MONTGOMERY COUNTY PLANNING DEPARTMENT
THE MARYLAND-NATIONAL CAPITAL PARK AND PLANNING COMMISSION

MEMORANDUM

REVIEW TYPE: **Site Plan Review**
CASE #: **82005003A**
PROJECT NAME: **Westfield Montgomery, Parcel A**
APPLYING FOR: A total of 1,601,556 square feet of commercial retail space, including 59,384 square feet of new space for retail and restaurant uses; and a parking waiver to allow a reduction in the number of spaces and to allow modification of the size of parking spaces in the parking structure. The new square footage includes 25,005 square feet from the existing strip center that has been acquired and included in the gsfc of the mall operations.
REVIEW BASIS: Section C-4.351 of the Zoning Ordinance requiring site plan review for a development containing a building that exceeds 42 feet in height.
Div. 59-D-3 of Montgomery County Zoning Ordinance
ZONE: C-2
LOCATION: Northeast quadrant of the intersection of Democracy Boulevard and Westlake Drive.
MASTER PLAN: Potomac Subregion Master Plan
APPLICANT: Montgomery Mall LLC

Applicant's plan of the proposed improvements to Westlake Drive (shaded)

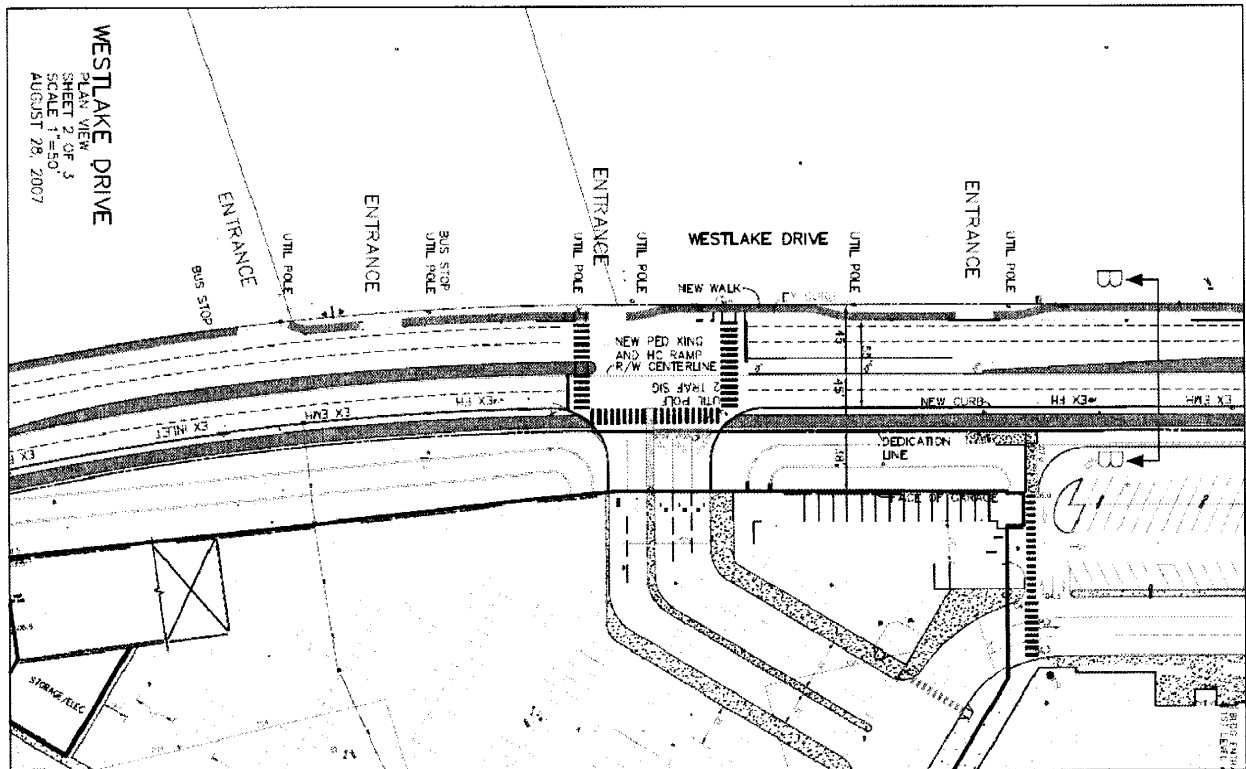
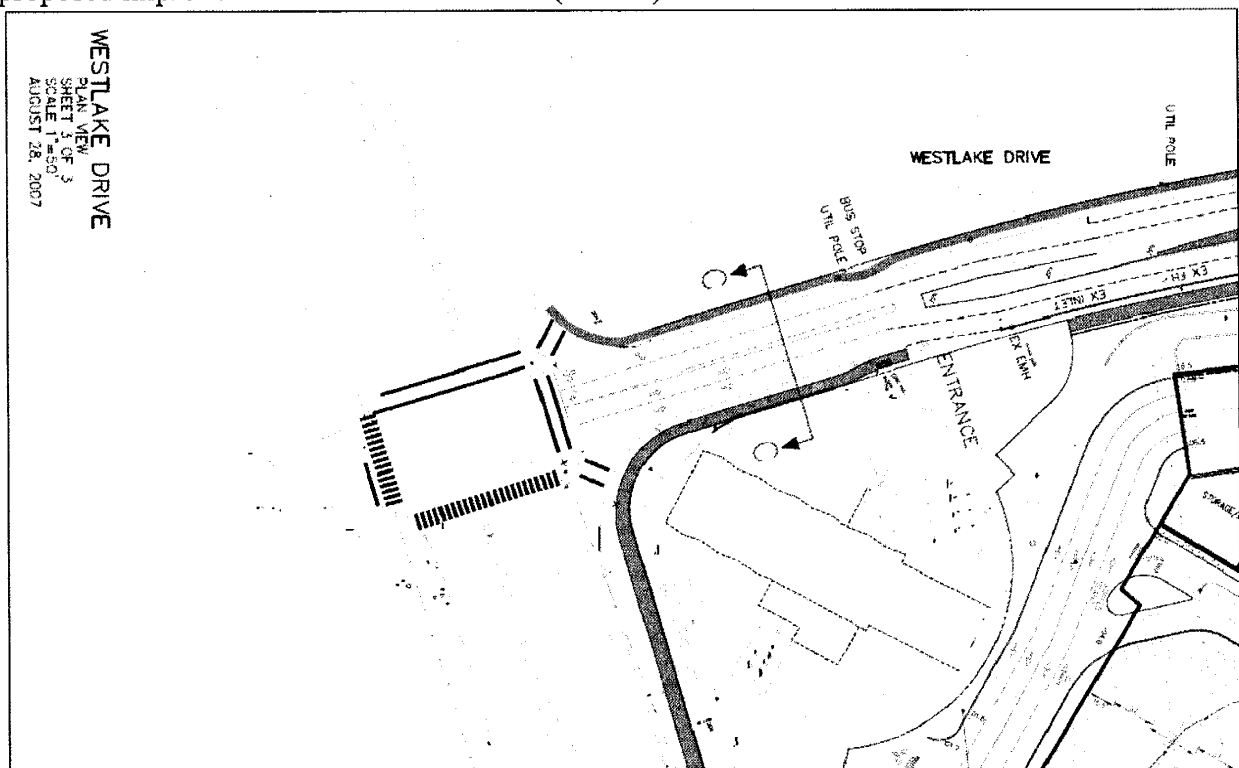
The Applicant is proposing to dedicate 10 feet of additional right-of-way along the east side of Westlake Drive to account for improvements to the road, including an 8-foot-wide shared-use path/off-road bike path, a five-foot wide landscape panel for shade trees, a 10-foot and 11-foot-wide through lane on the east side, 8-foot-wide raised median and two 10-foot-wide lanes on the west side. The Applicant and DPWT will need to continue working with property owners on the west side to provide for additional area for sidewalk, landscape panel and street trees and median improvements within the right-of-way.

The detailed final cross-section must be approved by the Planning Board staff and the Montgomery County Department of Public Works and Transportation (DPWT) and in consideration of the community's needs prior to certification of the site plan.

PROPOSED RIGHT OF WAY IMPROVEMENTS PER COUNTY/RESIDENTS

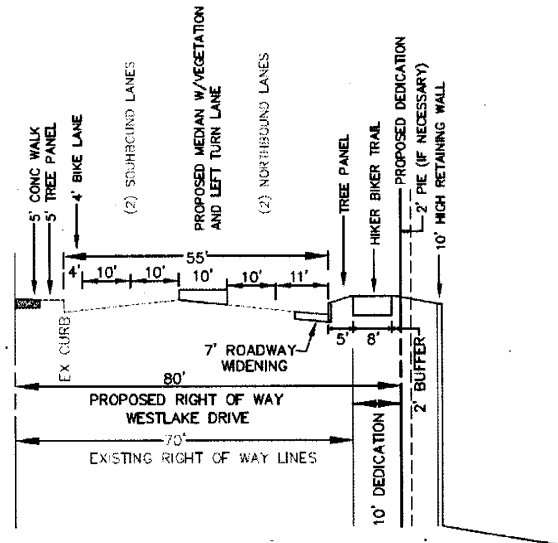
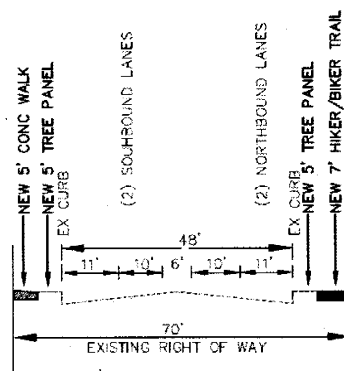
The detailed final cross-section must be approved by the Planning Board staff and the Montgomery County Department of Public Works and Transportation (DPWT) and in consideration of the community's needs prior to certification of the site plan.

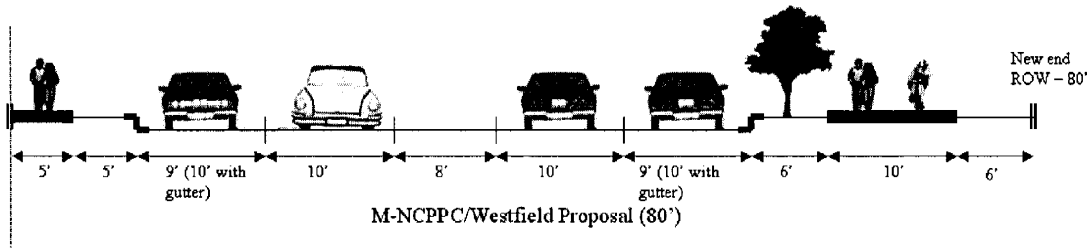
proposed as a visual green screen along Westlake Drive misrepresents the future planting size, both vertically and horizontally. The picture below depicts the actual size of trees proposed to be placed as a "landscaped green" along the façade of the existing garage on Westlake Drive. These 16-year old, mature trees show a maximum height of approximately 15 feet. The plan as proposed by Westfield would require that these trees have a growth at maturity of 35 feet. The rendering of the garage is not to scale for a facility that will ultimately reach a height of 66 feet above grade.

The design also allows for easy future expansion of additional structured parking along Westlake Drive at the location of the existing surface parking. This future parking would reverse the Westfield design that eliminated that portion of the parking garage that would impact the communities abutting Westlake Drive and the Mall.

The MMCAP has received considerable comments relative to the expansion of Macy's towards Democracy Boulevard. The neighborhood communities of Crestberry and Devonshire are concerned that the building massing will become more obtrusive on the southwest side of the expansion and that the mature trees and landscape screening provided in earlier expansions will be eliminated or damaged.

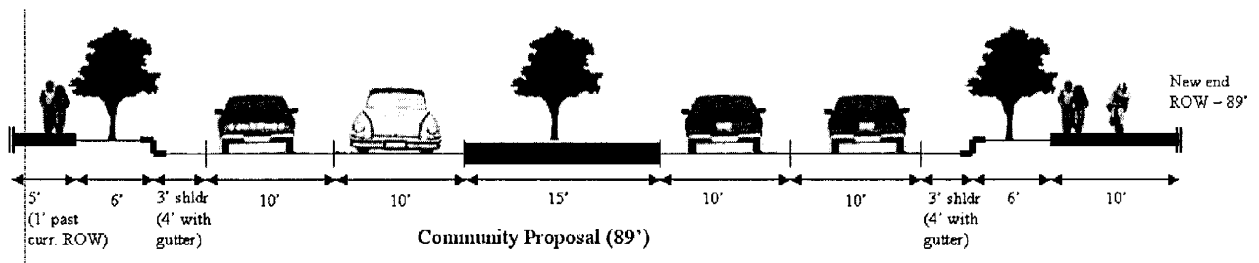
Reinstate the median (as depicted below). Per our earlier request, install a landscaped center median to replace the continuous two-way left turn lane. The median should be wide enough (14' to 15') to accommodate a 4' to 5' wide pedestrian refuge next to left turn lanes. That way the median can extend up to each intersection, making it a more effective pedestrian refuge (or barrier as warranted) and offering protection to drivers in left turn lanes from oncoming traffic. A wider median will also provide ample space for median trees and provide some measure of traffic calming. As an example, the median on westbound Veirs Mill Road as it approaches Ennalls Avenue is an effective center median with dimensions similar to those proposed by MMCAP for Westlake Drive.

Provide two more crosswalks. Provide two additional marked crosswalks across Westlake Drive between Westlake Terrace and the Mall entrance signal, including one at Lakeview Drive (a source of pedestrians) and one further south. The new plan's attempt to deter pedestrians from crossing anywhere along the 900' stretch of Westlake Drive south of Westlake Terrace is an unacceptable blow to pedestrian mobility. This is a critical segment where street-facing retail is now proposed, where Lakeview Drive enters and where residential density is highest. The

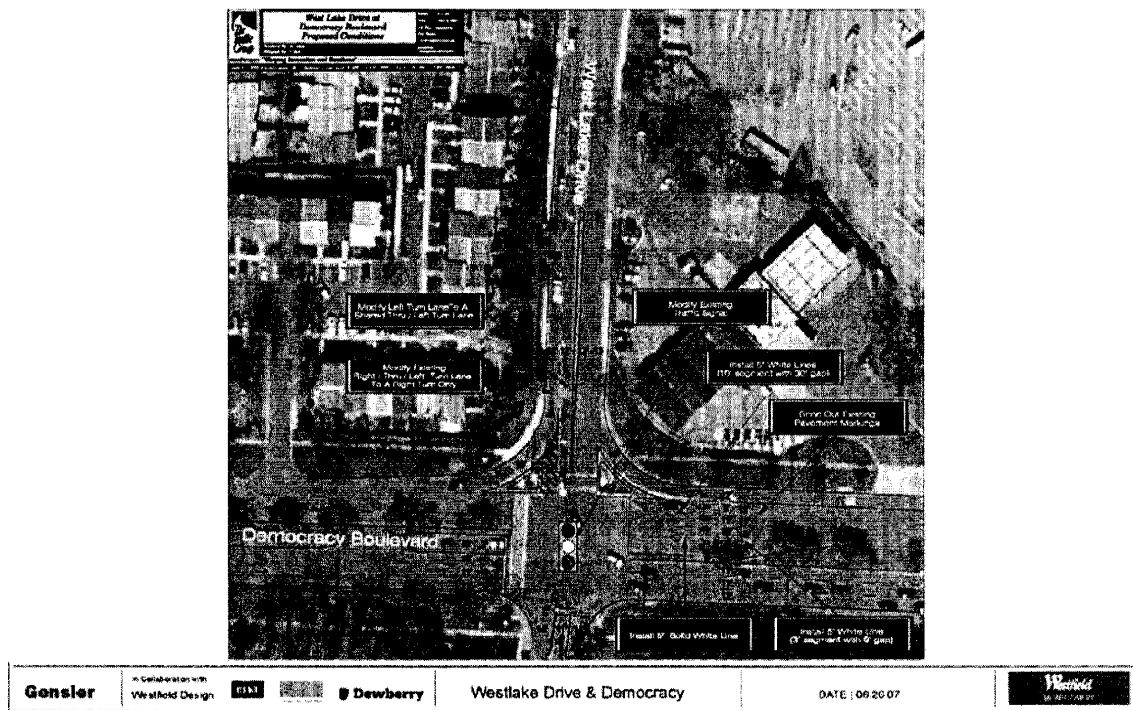
MMCAP considers the Mall area located the length of Westlake Drive from the gas station to Westlake Terrace as a potential opportunity to transition the Mall and the residential neighborhoods with a street-facing retail configuration. There are many examples of the new urbanistic and neighborhood friendly retail developments that will provide a buffer between the large Mall expansion, break up the Mall's exterior façade, and provide for the community retail that is currently serviced through the Westlake Crossing tenants. A prime example of this town retail concept is the New Rockville Town Center,

Ultimately, by relocating the monolithic parking garage on Westlake Drive to the potential areas within the Mall closer to I-270, the opportunity to maintain Westlake Crossing becomes far more viable. If the retaining the existing Westlake Crossing does not fit within the Westfield plan, a replacement street-facing retail area could be designed along Westlake Drive.
